SITE: 9 Miena Drive, Sorell

**PROPOSED DEVELOPMENT:
THREE MULTIPLE DWELLINGS**

Development Application: 5.2024.325.1 -
Response to Request For Information - 9
Miena Drive, Sorell - P2.pdf
Plans Reference: P2
Date received: 13/06/2025

PROPOSED SITE PLAN

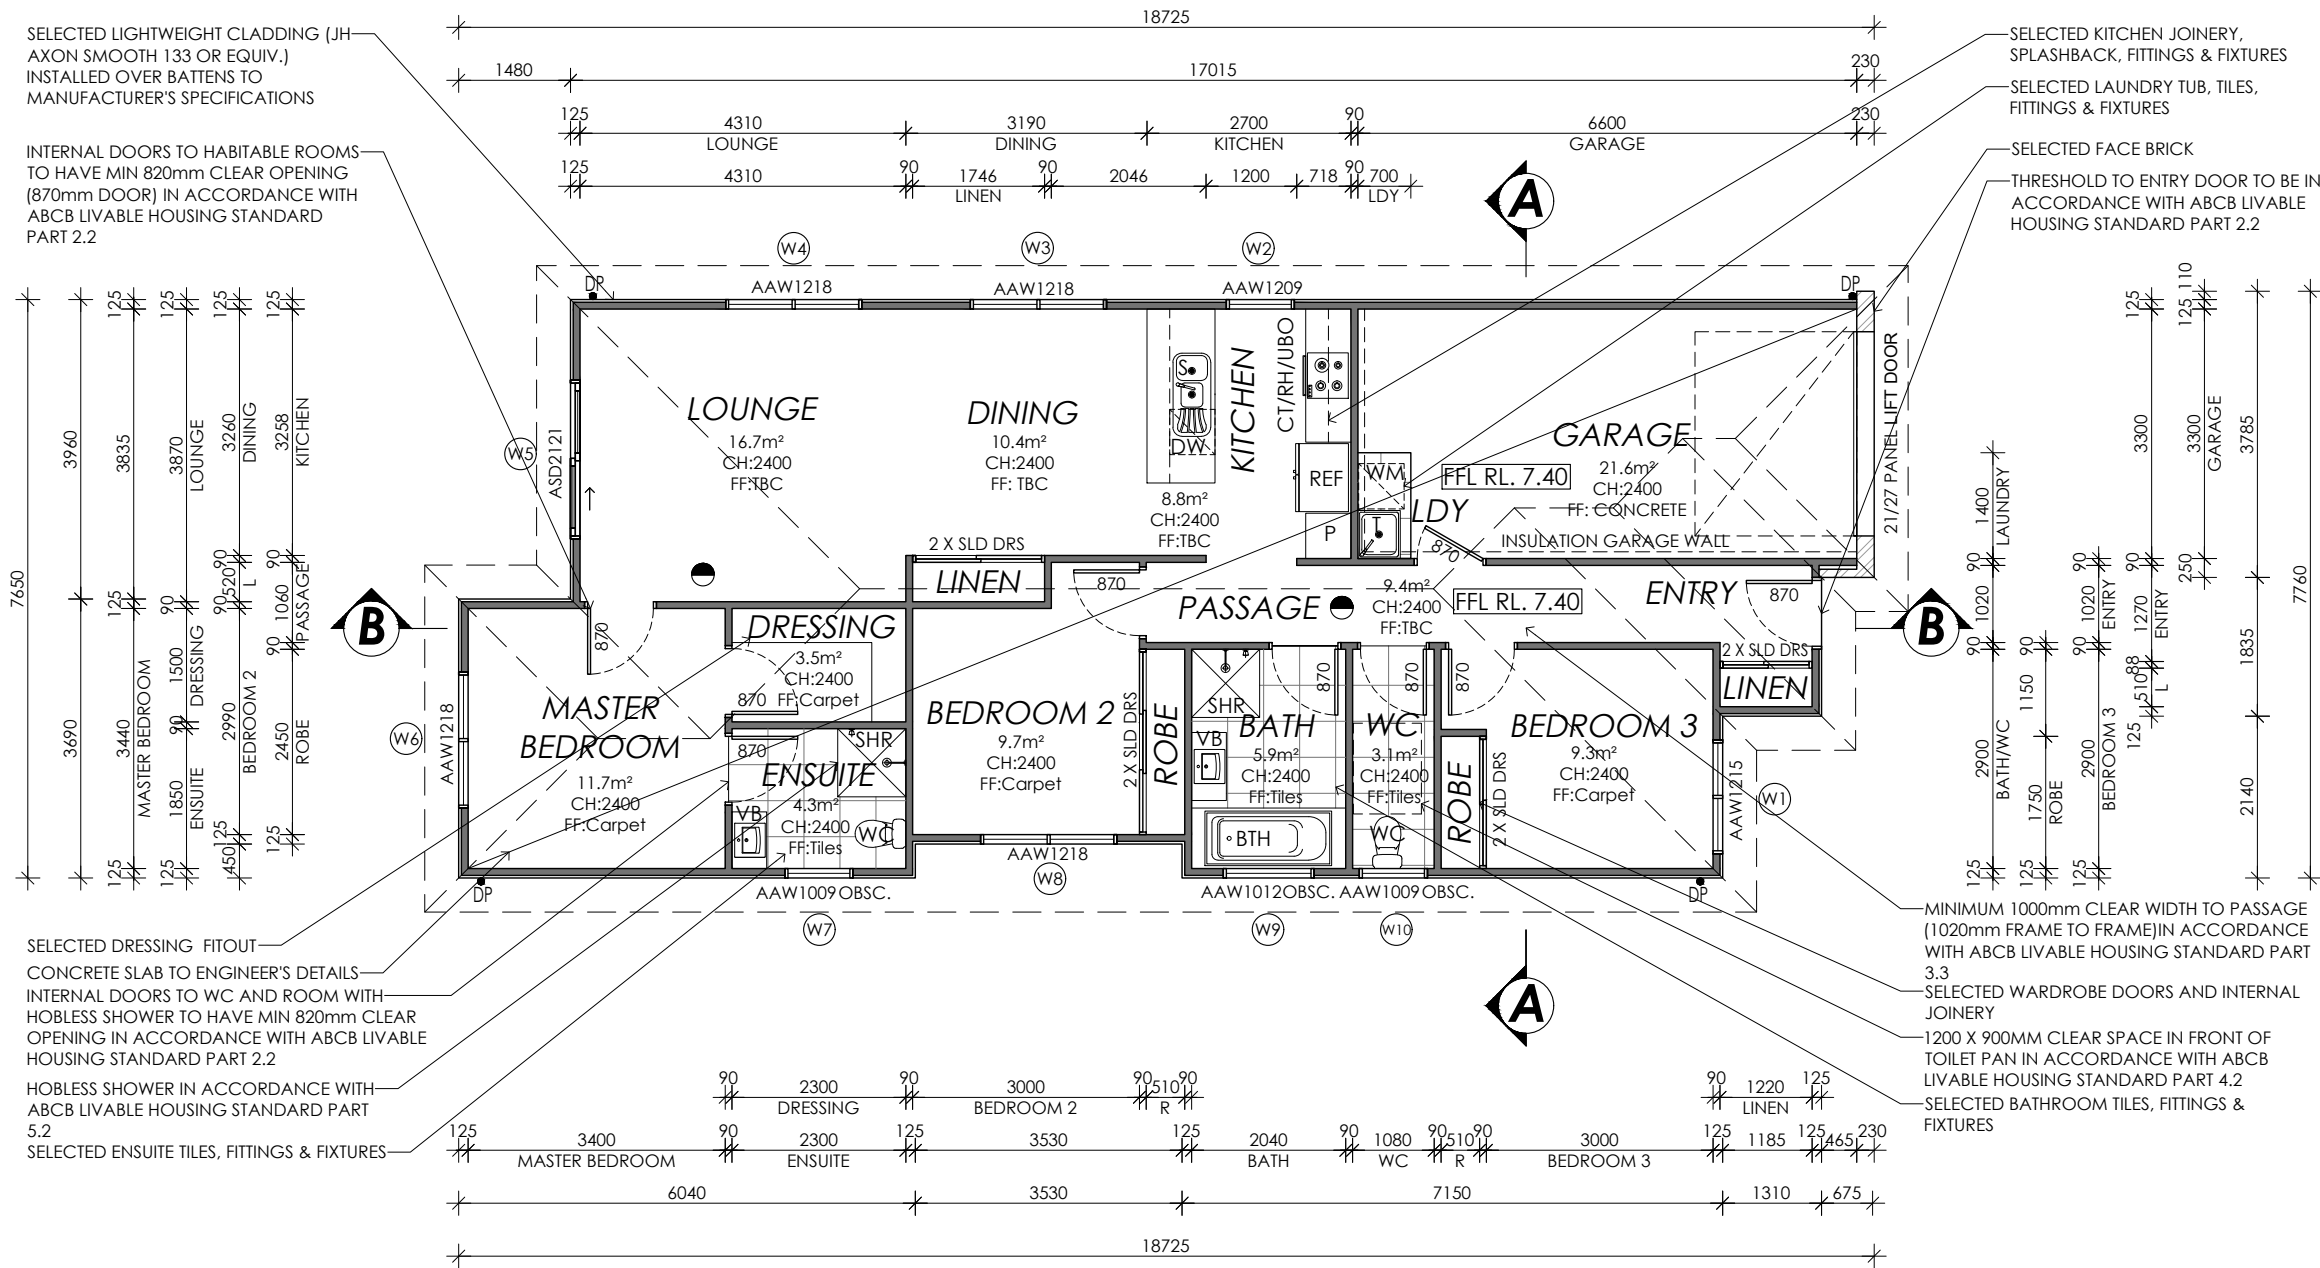
- *Site Coverage is significant, resulting in large hardstand coverage and limited appropriate landscaping (note large tree planting should not be confined to or be present within an easement area with vulnerable infrastructure that is likely to be damaged due to tree roots).*

- *Private Open Space (POS) is inadequate and inappropriately located. Specifically, Unit 2's proposed POS is unsatisfactorily located within the front setback, does not have a northern orientation, and requires an unacceptable solid front to provide any form of privacy.*

The hardstand at the front of the property has been reduced in size and a landscape feature has been added to minimise and break up the visual appearance of the concrete and make it appear less dominant. No large trees have been proposed – in accordance with the legend on the site plan – the “trees” are noted as screening plants, in addition to the other low growing species and grasses. This has been amended on the site plan for clarity and should also be read in conjunction with the landscaping schedule. The easement area has been amended to only include low growing species and grasses which will reduce the likelihood of roots impacting drainage infrastructure within the easement.

All units meet the requirements for a minimum of 24m² of primary private open space (with min 4m dimension) and also a minimum of 60m² of total private open space in accordance with the planning scheme. The private open space for unit 2 is within the front setback which has a proposed screen fence and landscaping in order to provide privacy while also eliminating the need for a solid/high fence to achieve this. This is consistent with other unit developments in the area where the private open space is unable to be located behind the building line – such as the adjoining property at 10-12 Parkside Place, Sorell (below)

As previously mentioned, the hardstand at the front of the property has been reduced in size and a landscape feature has been added to minimise and break up the visual appearance of a large expanse of concrete.
